SCHOOL DEVELOPMENT STANDARD DEPARTURE ADVISORY COMMITTEE

JOHN MUIR ELEMENTARY SCHOOL DEPARTURE RECOMMENDATIONS

Project # 3040569-SD
JANUARY 18, 2024

Departure #1 - Lot Coverage

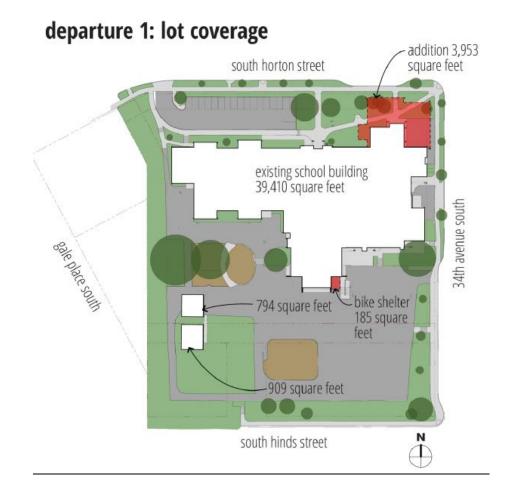
- 1) The appropriateness to the character and scale of the surrounding area was considered by the committee, and they did not have any concerns about the school's required lot coverage having an impact on its relationship to the surrounding area.

- 2) The presence of edges (significant setbacks, major arterials, topographic breaks, and similar features) that provide a transition in scale was considered by the committee, and they did not have any concerns about the school's required lot coverage having an impact on the transition in scale.

- 3) The location and design of structures to reduce the appearance of bulk were considered by the committee, and they did not have any concerns about the school's required lot coverage having an impact on the appearance of bulk.

- 4) **Impacts on traffic, noise, circulation, and parking in the area** were considered by the committee, and they did have concerns about the proposed lot coverage having an impact

- on traffic, circulation, and parking in the neighborhood. The committee recommends that the school send out timely communication plan updates about the status of traffic and pedestrian safety before and after the construction.
- 5) **Impacts on housing and open space** were considered by the committee, and they did not have any concerns about the school's requested lot coverage having an impact on housing and open space.

The committee's deliberation revolved around traffic circulation, noise, and safety during construction. The committee agreed that it would be the school district's responsibility to address the concerns about traffic circulation through an updated communication plan to parents, school staff volunteers, and nearby neighbors.

Recommendation – That the departure that allows 38% lot coverage for a departure of 3% to be GRANTED as requested by the Seattle Public Schools with the following conditions.

- 1) Transportation Management Plan (TMP): SPS and the principal of John Muir Elementary School should establish a TMP to educate families about traffic and pedestrian safety during construction.
- 2) **Neighborhood Communication Plan:** SPS and John Muir Elementary School administration should develop a neighborhood communication plan to inform nearby neighbors about parking, noise, traffic, and circulation during construction.

departure 2: setback at south horton street

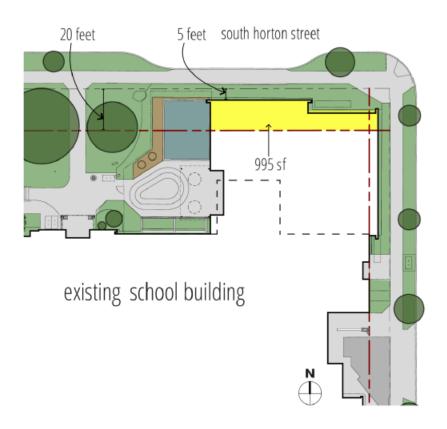
- 1) The appropriateness to the character and scale of the surrounding area was considered by the committee, and they did not have any concerns about the school's required setbacks having an impact on its relationship with the surrounding area.

- 2) The presence of edges (significant setbacks, major arterials, topographic breaks, and similar features) that provide a transition in scale was considered by the committee, and they did not have any concerns about the school's required setbacks having an impact on the transition in scale.

- 3) The location and design of structures to reduce the appearance of bulk were considered by the committee, and they did not have any concerns about the school's required setback having an impact on the appearance of bulk.

- 4) Impacts on traffic, noise, circulation, and parking in the area were considered by the committee, and they did not have concerns about the proposed setbacks having an impact on traffic, circulation, and parking in the neighborhood.

- 5) Impacts on housing and open space were considered by the committee, and they did not have concerns about the school's requested setbacks having an impact on housing and open space.

Recommendation – That the departure that allows a 5-foot setback for an 82-foot long portion of the building along South Horton Street, for a departure of 15 feet and a 5-foot setback for a 63-foot long portion of the building along 34th Avenue South, for a departure of 4 feet, 7 inches to be GRANTED as requested by the Seattle Public Schools

departure 4: bicycle parking quantity

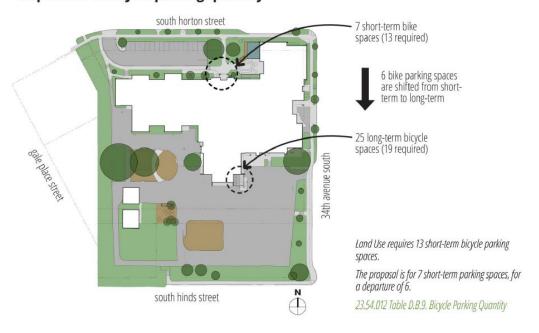
One committee member expressed concern about reducing the bicycle parking quantity but noted that the School District did manage to address the concern by shifting some of the short-term bicycle parking to long-term.

- 1) The appropriateness to the character and scale of the surrounding area was considered by the committee, and they did not have any concerns about the school's required bicycle parking quantity having an impact on its relationship to the surrounding area.

- 2) The presence of edges (significant setbacks, major arterials, topographic breaks, and similar features) that provide a transition in scale was considered by the committee, and they did not have any concerns about the school's required bicycle parking quantity having an impact on the transition in scale.

- 3) The location and design of structures to reduce the appearance of bulk were considered by the committee, and they did not have any concerns about the school's required bicycle parking quantity having an impact on the appearance of bulk.

- 4) **Impacts on traffic, noise, circulation, and parking in the area** were considered by the committee, and they did not have concerns about the proposed bicycle parking quantity having an impact on traffic, circulation, and parking in the neighborhood.

- 5) **Impacts on housing and open space** were considered by the committee, and they did not have concerns about the school's requested bicycle parking quantity having an impact on housing and open space.

Recommendation — That the departure that allows for seven short-term bicycle parking spaces, for a departure of 6 to be GRANTED as requested by the Seattle Public Schools without modifications.
